**Re: Case No. 20-1605-EL-BGN -** In the Matter of the Application of Birch Solar 1, LLC for a Certificate of Environmental Compatibility and Public Need to Construct a Solar-Powered Electric Generation Facility in Allen and Auglaize Counties, Ohio.

**Response to Ninth Data Request from Staff of the Ohio Power Siting Board**

**BIRCH SOLAR 1, LLC 'S**
**RESPONSE TO THE NINTH DATA REQUEST**
**FROM THE STAFF OF THE OHIO POWER SITING BOARD**

# EM Survey Transects

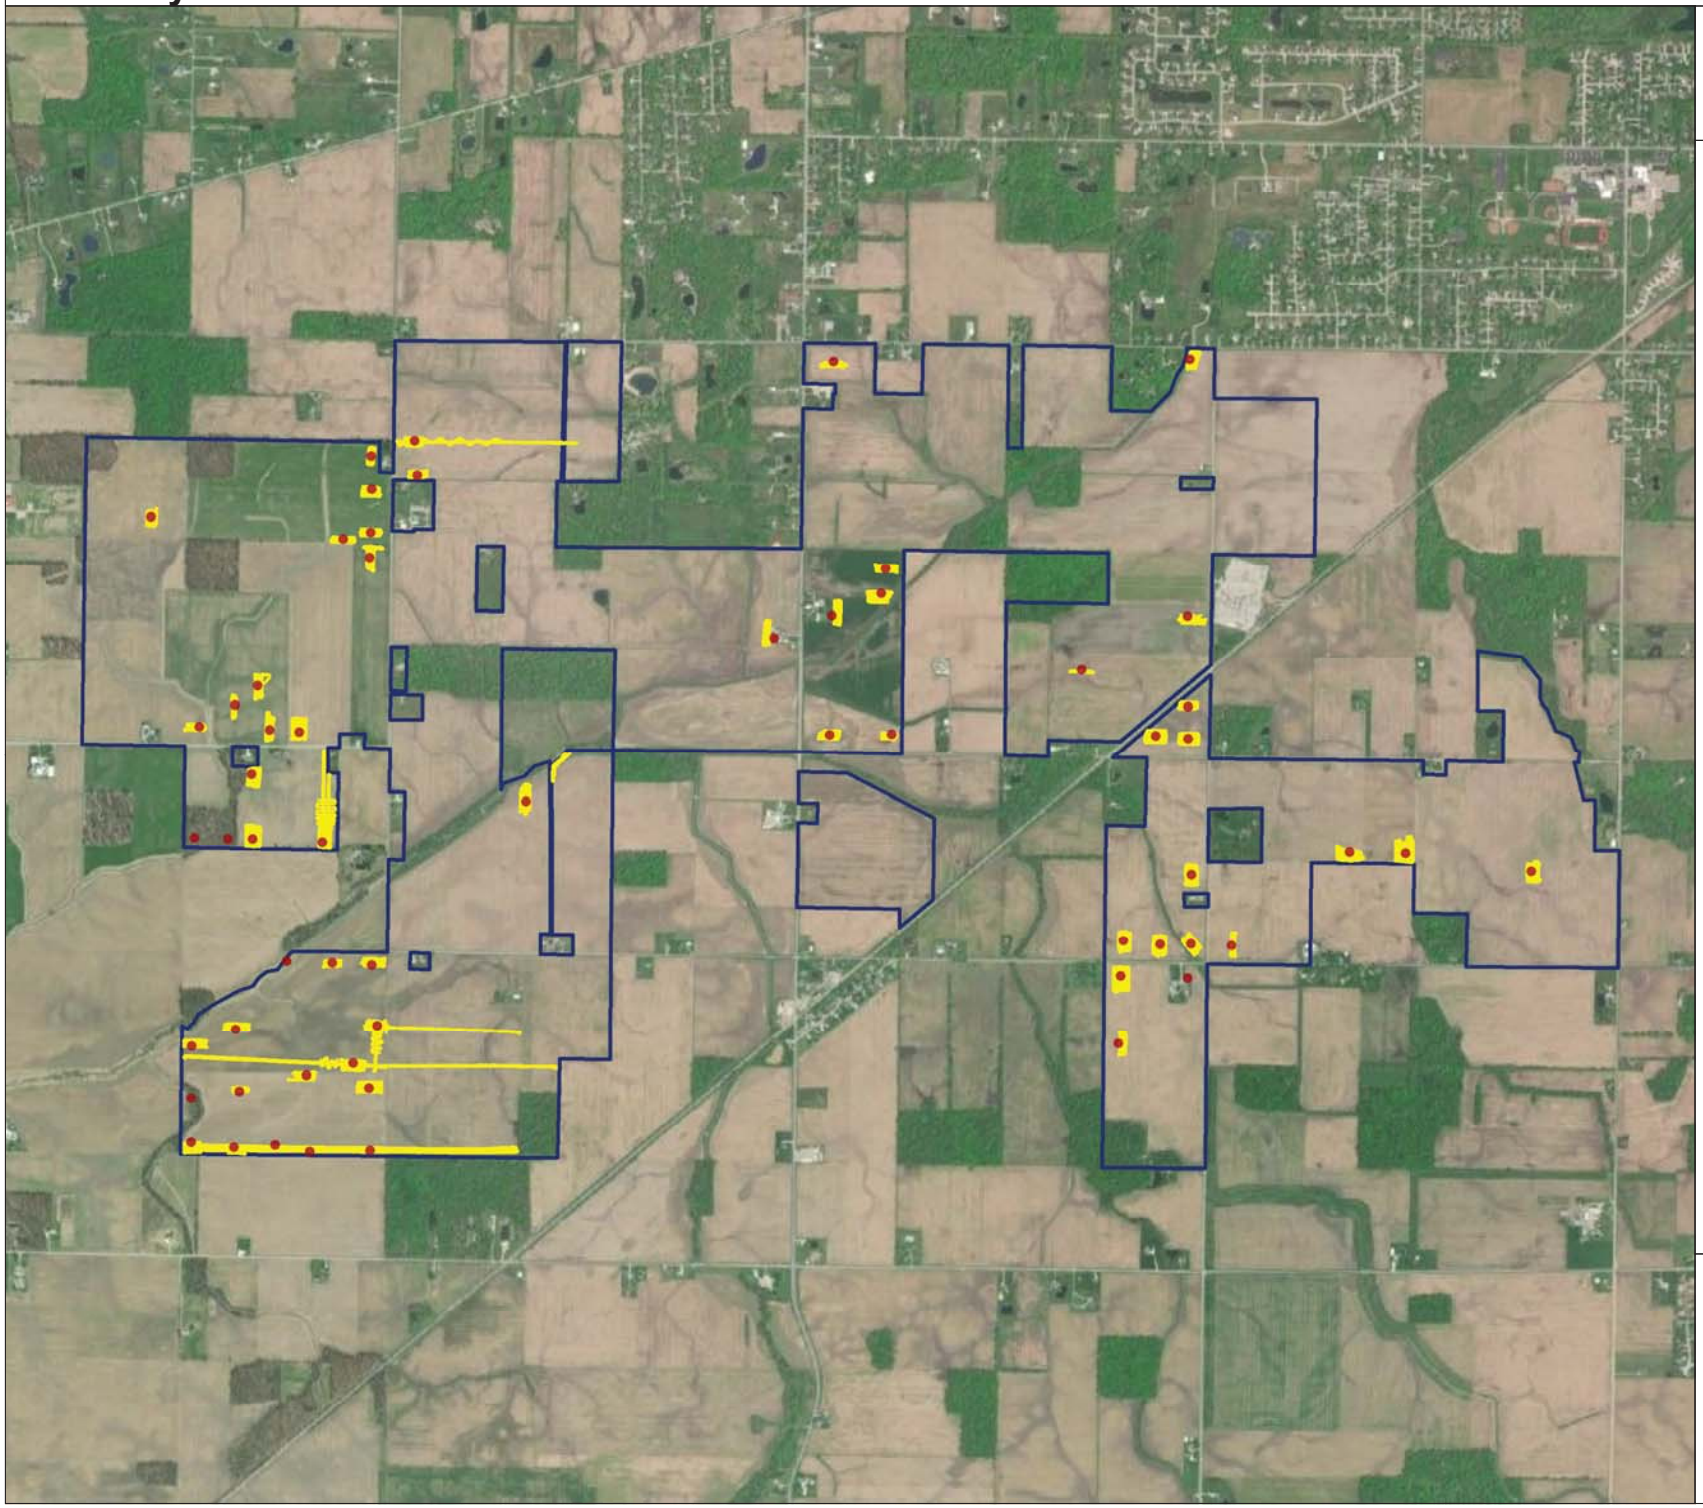
7. **A figure depicting the locations of these wells and any associated infrastructure within the current project layout.**

8. **A figure depicting the locations of these wells and any associated infrastructure within any revised project layout observing a 50-foot setback from oil and gas well features.**

9. **A modified Figure 8-3 that shows the well locations provided with the application, the identification of any new wells, and revised locations of wells previously identified.**

**Response:** Please see Figure 1 and Figure 2 in Attachment 1 to this response.

**Response:** Please see Figure 1 and Figure 2 in Attachment 1 to this response. Please note, setbacks were removed from any area which could not be physically verified through the methods outlined above.

**Response:** Please see Figure 1 and Figure 2 in Attachment 1 to this response.
